HISTORIC AND DESIGN REVIEW COMMISSION

HDRC CASE NO: 2022-593
ADDRESS: 109 W MULBERRY AVE
LEGAL DESCRIPTION: NCB 1768 BLK 3 LOT W 25 FT OF 17 & E 25 FT OF 16
ZONING: R-4, H
CITY COUNCIL DIST.: 1
DISTRICT: Monte Vista Historic District
APPLICANT: Steve Graham/HOMEUP LLC
OWNER: Mary Stopper/STOPPER MARY MARGARET
TYPE OF WORK: Front-yard fence, front-yard turf, driveway and apron, construction of a 10'x24' backyard shed, hardscaping (rear patio)
APPLICATION RECEIVED: December 02, 2022
60-DAY REVIEW: Not Applicable due to City Council Emergency Orders
CASE MANAGER: Jessica Anderson

REQUEST:

PLOT PLAN FOR BUILDING PERMITS

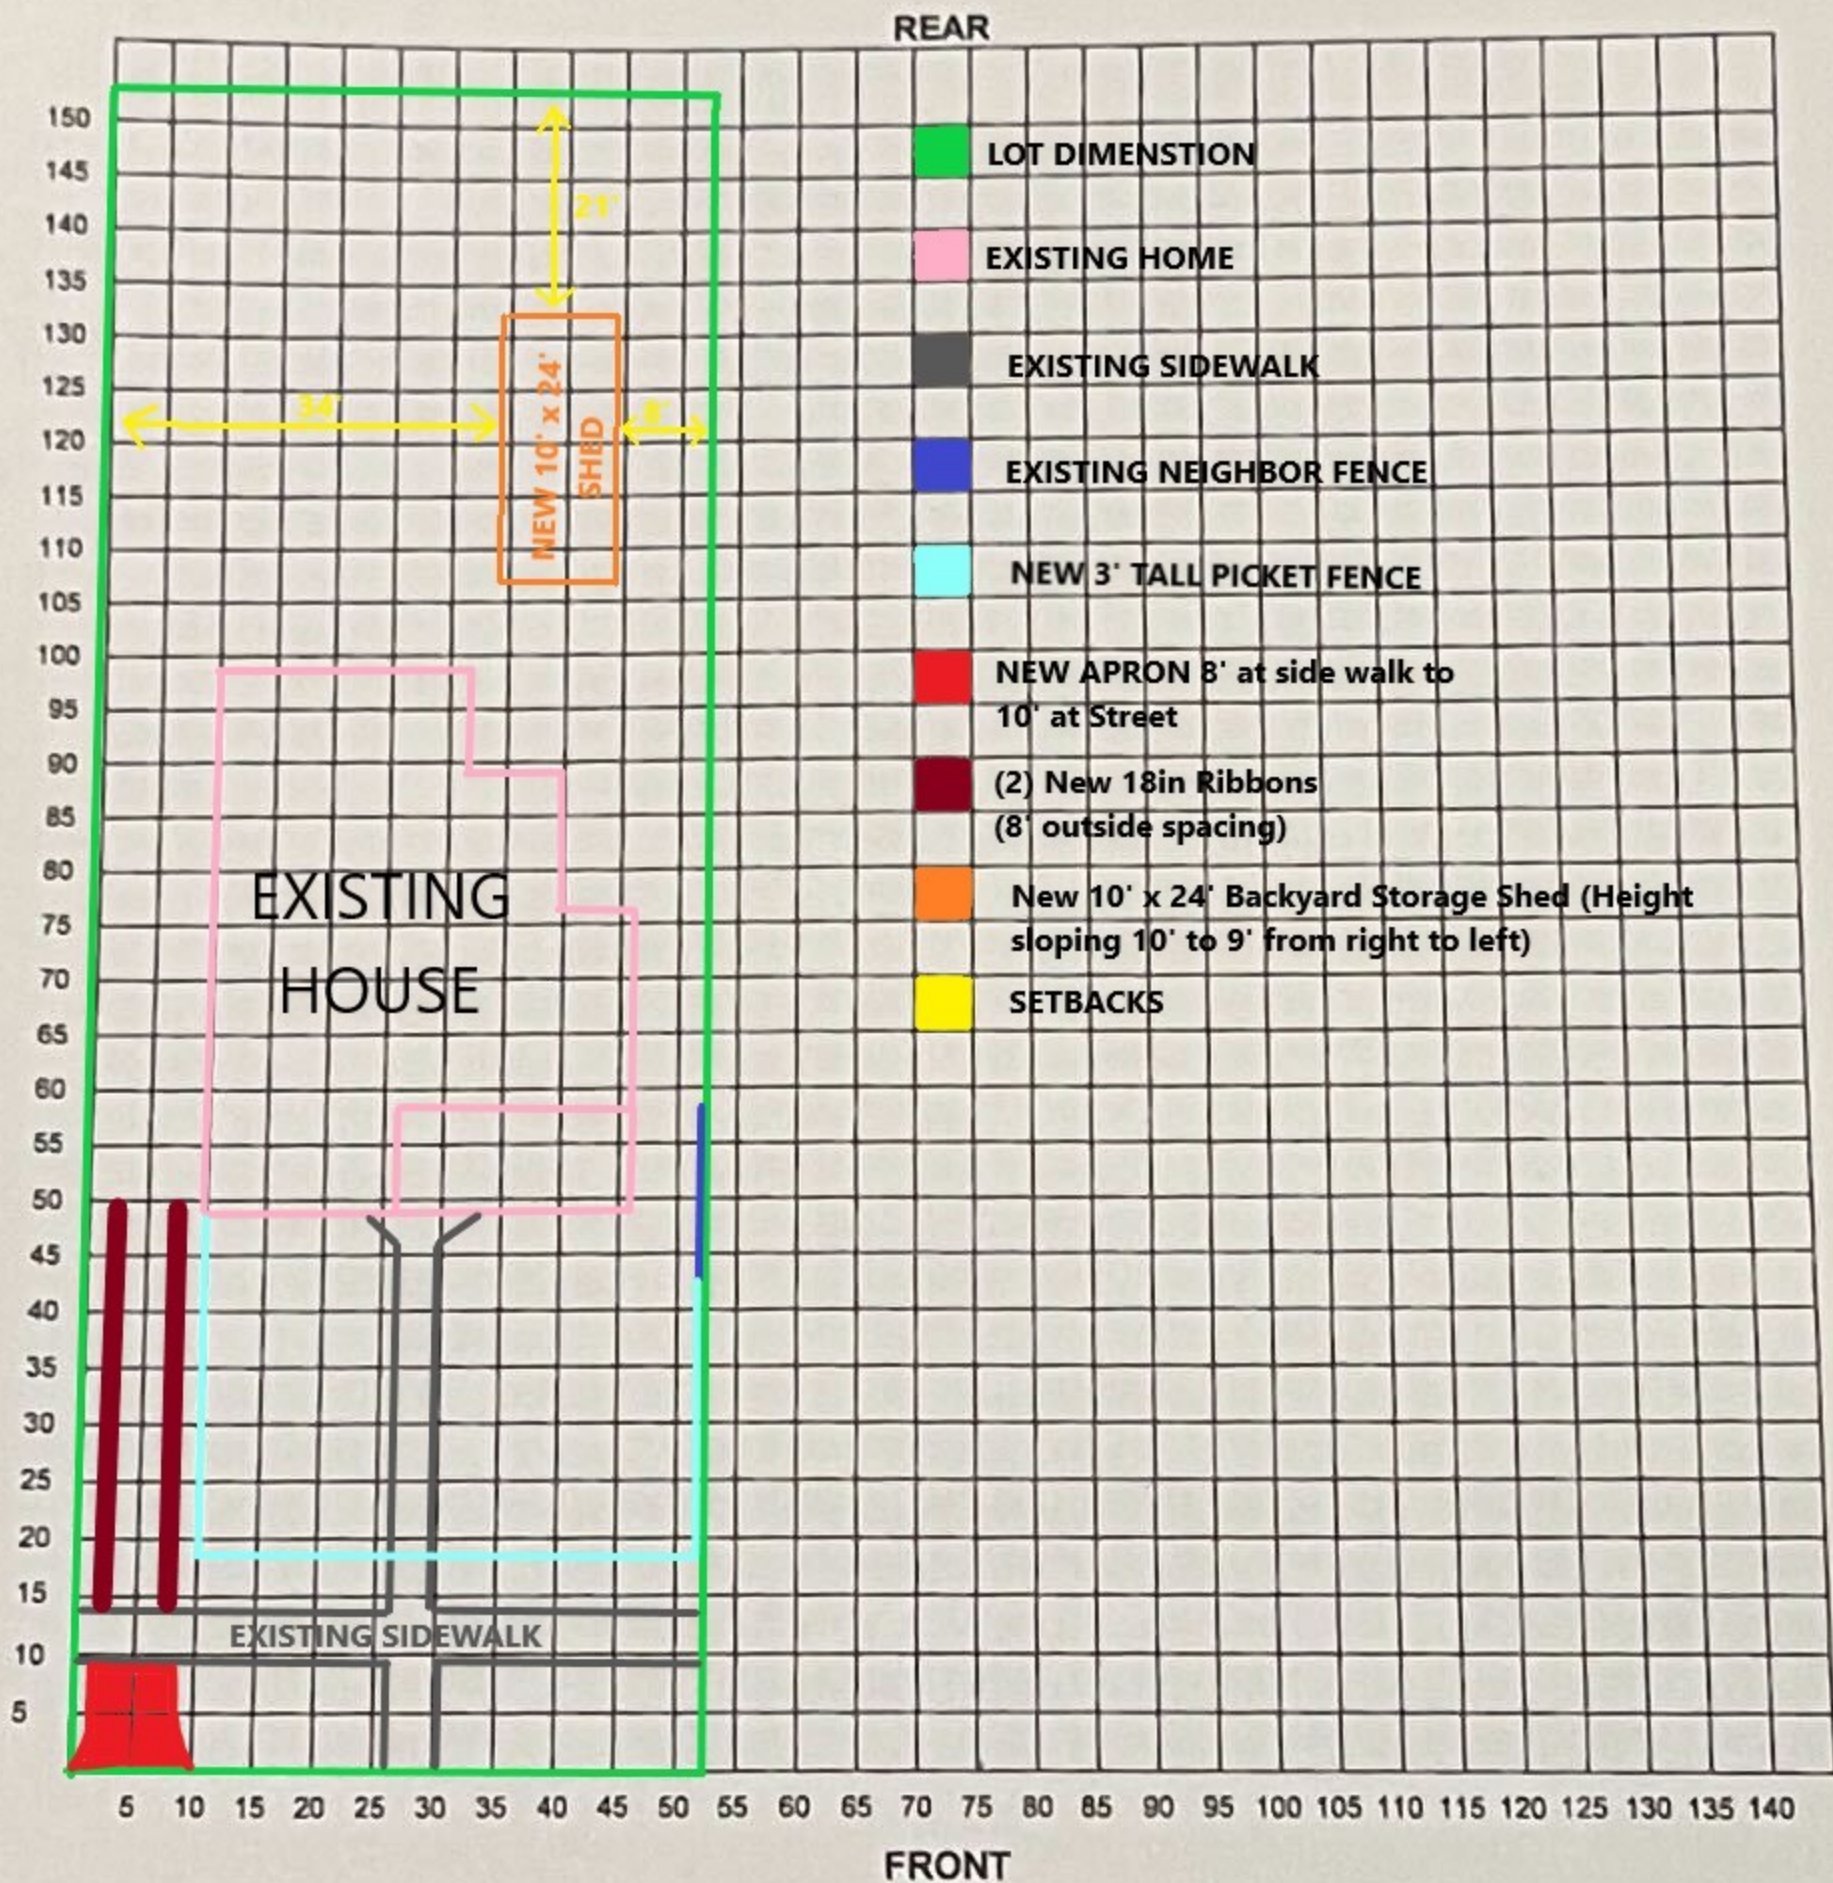
- c. FRONT-YARD FENCE: The applicant requests approval to install a wood picket front-yard fence that is 3' tall with gates at the front walkway and on the side next to the proposed driveway. Historic Design Guidelines for Site Elements 5.B.ii states that the appropriateness of a front yard fence or wall is dependent on conditions within a specific historic district. New front yard fences or wall should not be introduced within historic districts that have not historically had them. The Monte Vista neighborhood was designed with natural, open lawns; staff only noted two properties on adjacent blocks with front-yard fences—one was a low stone wall topped in a metal fence, and the other was a solely a metal fence. Staff finds the request does not conform to guidelines.

- d. ARTIFICIAL TURF: The applicant requests to add artificial turf to the front yard. Historic Design Guidelines for Site Elements 3.A.ii says to limit the removal of lawn areas to mulched planting beds or pervious hardscapes in locations where they would historically be found, such as along fences, walkways, or drives. Staff finds the request does not conform to guidelines.

- e. DRIVEWAY: The applicant requests approval to add an 8'-wide concrete ribbon drive with an apron flaring from 8' at the sidewalk to 10' at the street. Historic Design Guidelines for Site Elements 5.B.i says to incorporate a similar driveway configuration—materials, width, and design—to that historically found on the site, and that historic driveways are typically no wider than 10 feet. Guideline 5.B.ii says avoid introducing new curb cuts where not historically found. Though the property did not historically feature a driveway, staff finds the 8'-wide ribbon driveway with apron that tapers to 10' generally appropriate.

- h. PATIO: The applicant requests approval to install a 15'x35' concrete paver patio next to the proposed backyard shed. Historic Design Guidelines for Site Elements 3.B.ii says new pervious hardscapes should be limited to areas that are not highly visible, and should not be used as wholesale replacement for plantings. The backyard is not visible from the right of way, and the rest of the yard will include gravel with plantings, as described in finding b. Staff finds the concrete paver patio generally appropriate.

Staff recommends denial of item 1, installation of a front-yard fence, based on finding c.

Staff recommends denial of item 2, addition of artificial turf to the front yard, based on finding d. A request to install plantings or traditional lawn instead of artificial turf is eligible for administrative approval and would not require review by the HDRC.

Staff recommends approval of item 3, addition of an 8'-wide concrete ribbon drive with an apron flaring from 8' at the sidewalk to 10' at the street, based on finding e.

Staff recommends approval of item 5, installation of a 15'x35' concrete paver patio next to the proposed backyard shed, based on finding g.

New Backyard shed $\frac{10' \times 24'}{(240 \text{ ft}^2)}$

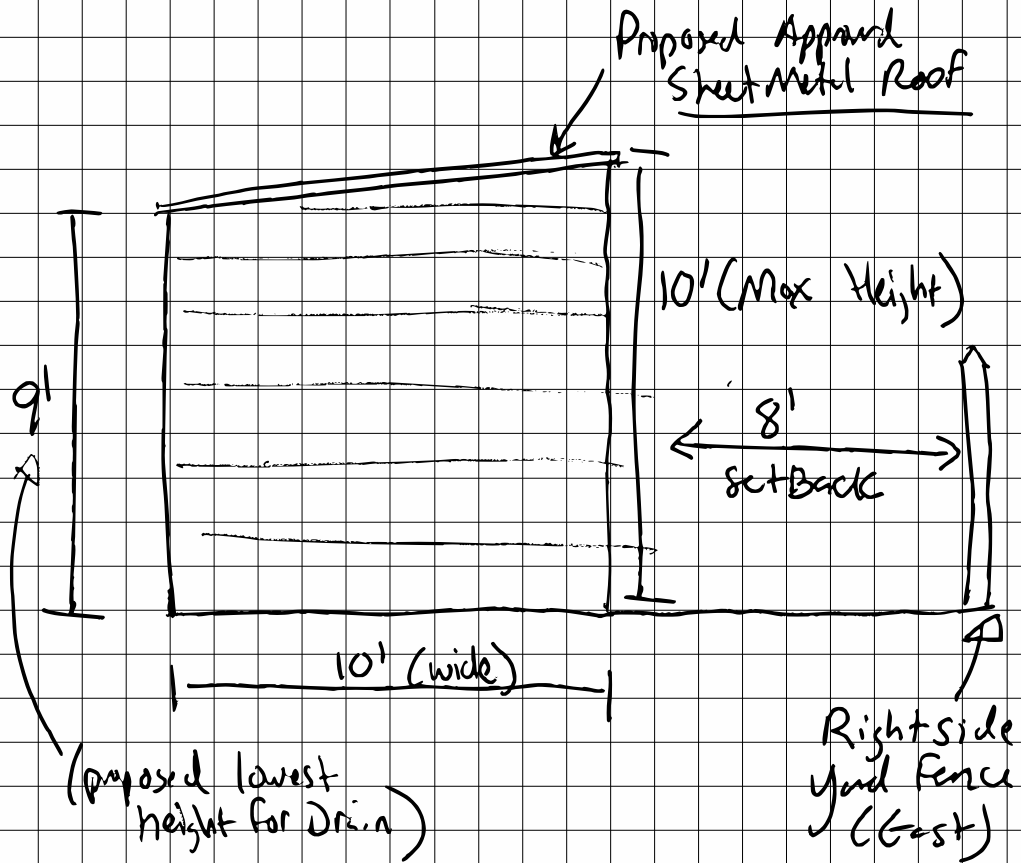
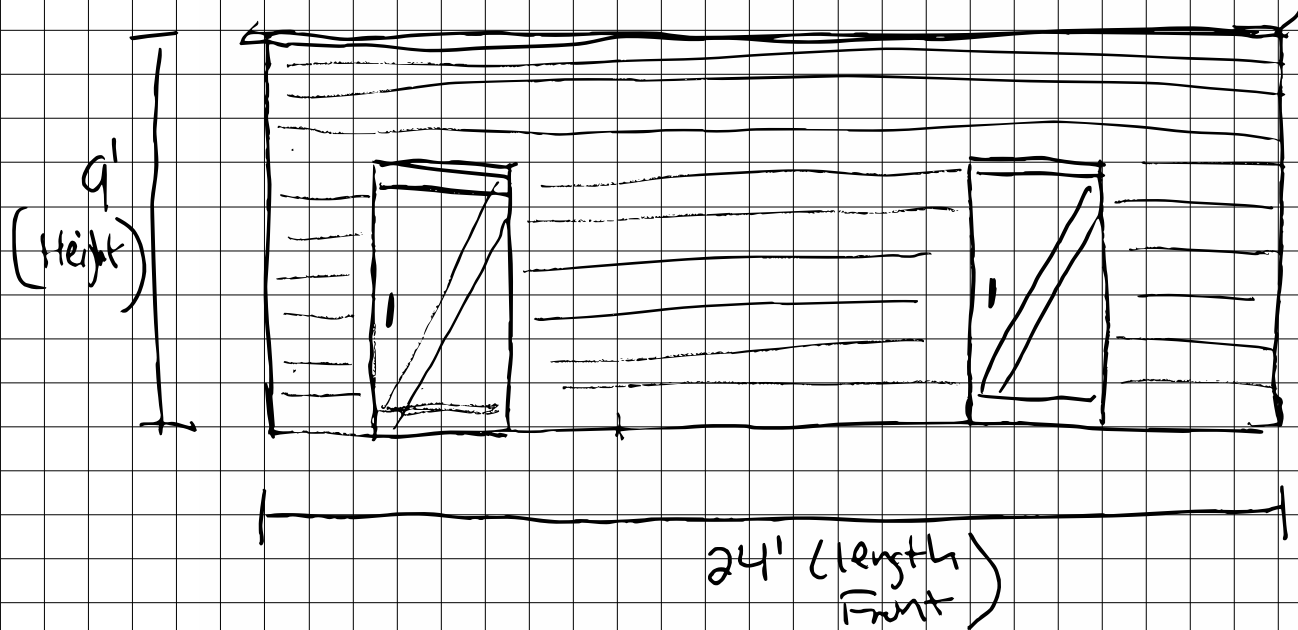
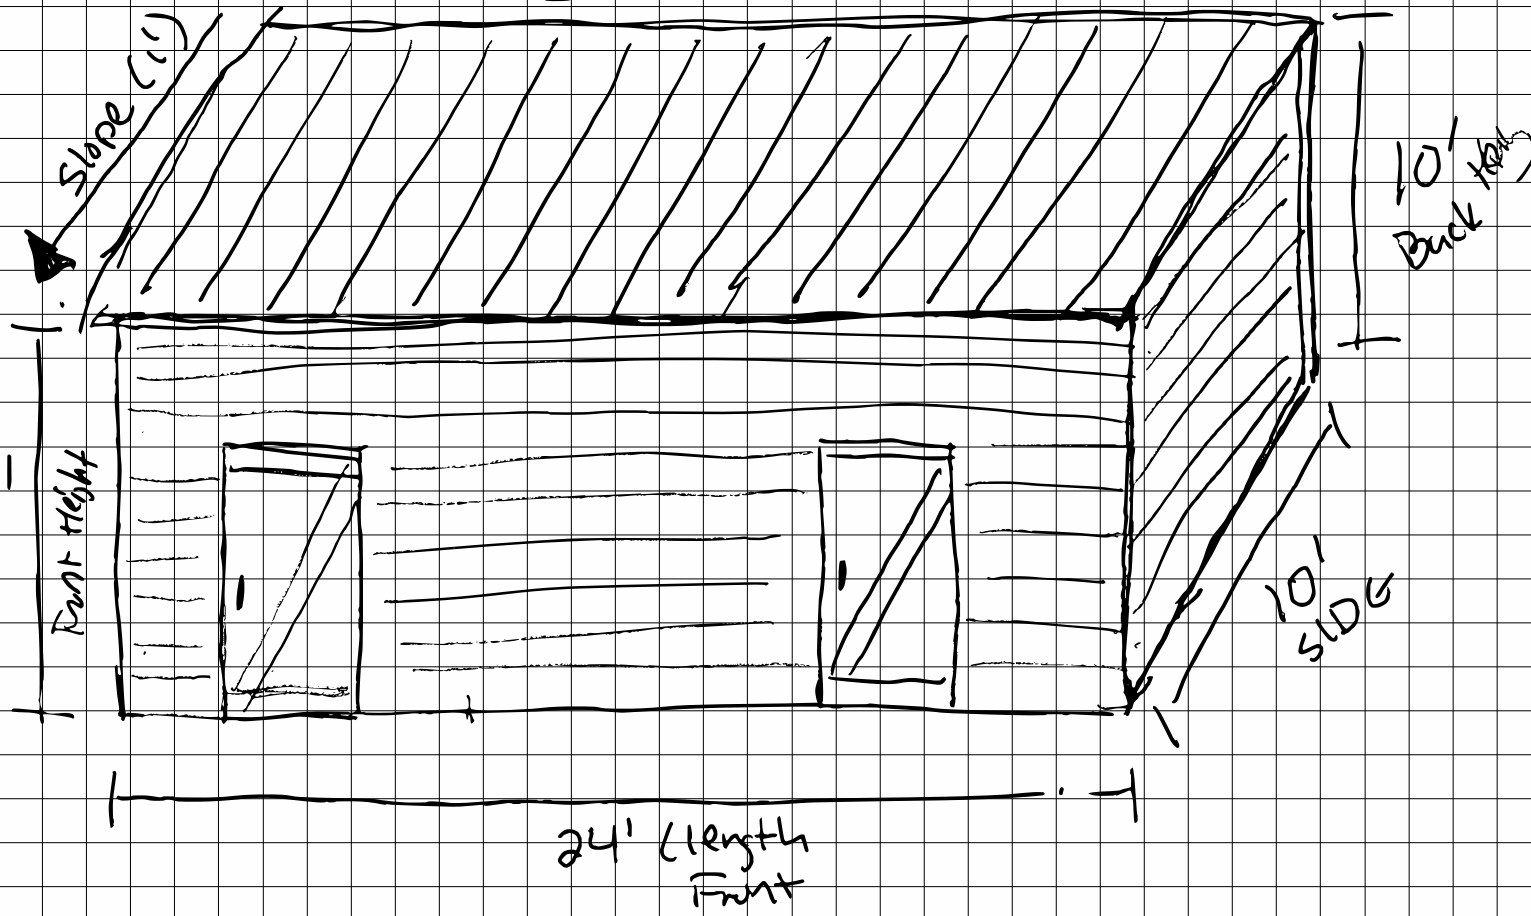
- f. NEW CONSTRUCTION (SHED): The applicant requests approval to construct a 10'x24' backyard shed. The proposed sheet-metal roof will slope from 9' on the west elevation to 10' on the east elevation; the metal roof will match that . It will be clad in horizontal Hardieboard sheet siding and painted to match the house. It will feature two wood doors on the west elevation, but no other fenestration. Historic Design Guidelines for New Construction 5.A.i and ii state that new garages and outbuildings to be visually subordinate to the principal historic structure in terms of their height, massing, and form and should be no larger in plan than 40 percent of the principal historic structure footprint. The house is 1,158 square feet according to BCAD; the proposed shed is visually subordinate to the house and is 240 square feet, or just over 20% of the square footage of the house. Staff finds the proposed shed conforms to guidelines, but that Hardi siding should be installed as lap siding with a 4" reveal.

- g. NEW CONSTRUCCION (SHED: ROOF FORM): The applicant proposes a metal-clad shed roof that slopes from 9' up to 10'. Historic Design Guidelines for New Construction 5.A.iii says to relate new garages and outbuildings to the period of construction of the principal building on the lot through the use of complementary materials and simplified architectural details. While the metal material is appropriate, staff finds that the shed roof form does not conform to guidelines.

Staff recommends approval of item 4, construction of a 10'x24' backyard shed, based on findings f and g, with the following stipulations:

- i. That the horizontal Hardie siding be installed with a 4" reveal, smooth side out.
- ii. That the applicant proposes a hipped or gabled roof form.
